# Access Compliance Report

## Public Rights-of-Way

### (Curb Ramps)

Intersection ID: 2639	Main Street: GRAHAMSON_LN	Cross Street: HARTFIELD_DOWNS_DR	Location: E
ADA ID: 45B4094BF4CA	Ramp Type: Perp	Initial Pass/Fail: Fail	Overall Compliance: No
Severity Score: 37.5			
Codes/Mitigation Info/Possible Solution		Field Measurements/Component Compliance

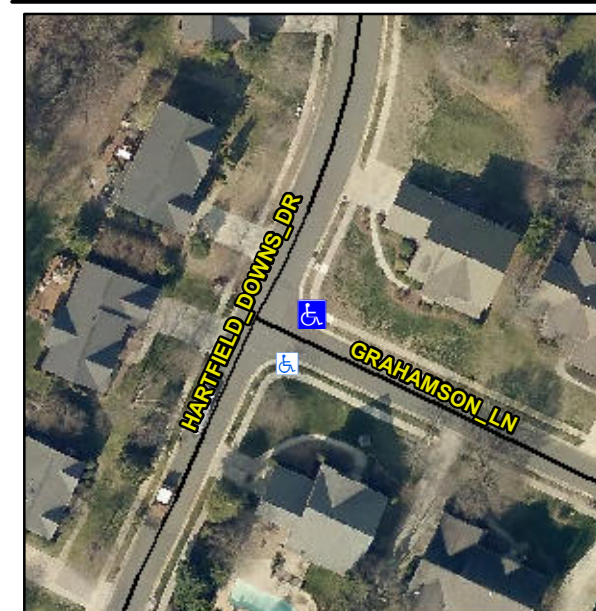
**Not Found, R304.2.2, R304.5.3**

Compliance	Description	Data	Compliance	Description	Data
N/A	Ramp Length (in)	50.0	No	Ramp Slope (%)	8.5
Yes	Ramp Width (in)	130.0	No	Ramp XSlope (%)	8.6
N/A	Flare Type LT	N/A	N/A	Flare Type RT	N/A
N/A	Flare Slope LT (%)	N/A	N/A	Flare Slope RT (%)	N/A
N/A	Flare Traversable LT?	N/A	N/A	Flare Traversable RT?	N/A
N/A	Landing Length (in)	N/A	N/A	DWS Provided?	N/A
N/A	Landing Width (in)	N/A	N/A	DWS Contrast?	N/A
N/A	Landing Slope (%)	N/A	N/A	DWS Length (in)	N/A
N/A	Landing X Slope (%)	N/A	N/A	DWS Full Width?	N/A
N/A	Landing Curb? (Y/N)	N/A	N/A	DWS Offset (in)	N/A
N/A	Shared Landing?	N/A			
N/A	Gutter Ponding?	N/A	N/A	Gutter Slope (%)	N/A
N/A	Gutter Lip Ht (in)	N/A	N/A	Gutter X Slope (%)	N/A
N/A	Painted X Walk1?	No	N/A	Painted X Walk2?	N/A
	X Walk 1 Direction	To SW		X Walk 2 Direction	N/A
N/A	X Walk 1 Width (in)	N/A	N/A	X Walk 2 Width (in)	N/A
	X Walk 1 Slope (%)	1.3		X Walk 2 Slope (%)	N/A
	X Walk 1 X Slope (%)	8.6		X Walk 2 X Slope (%)	N/A

N/A	Ramp inside XWalk1?	N/A	N/A	Ramp inside XWalk2?	N/A
	Road Slope (%)	N/A	N/A	Clear Space?	N/A
	Road X Slope (%)	N/A	N/A	Clear Space to XWalk (in)	N/A
N/A	Any Obstructions?	N/A	N/A	Storm Grate/Utility Hazard?	N/A
	Obstruction Type			Storm Grate/Utility Type	
		N/A			N/A
			Yes	Surface Condition? (G/P)	Good

**Remove & Replace Entire Ramp.**
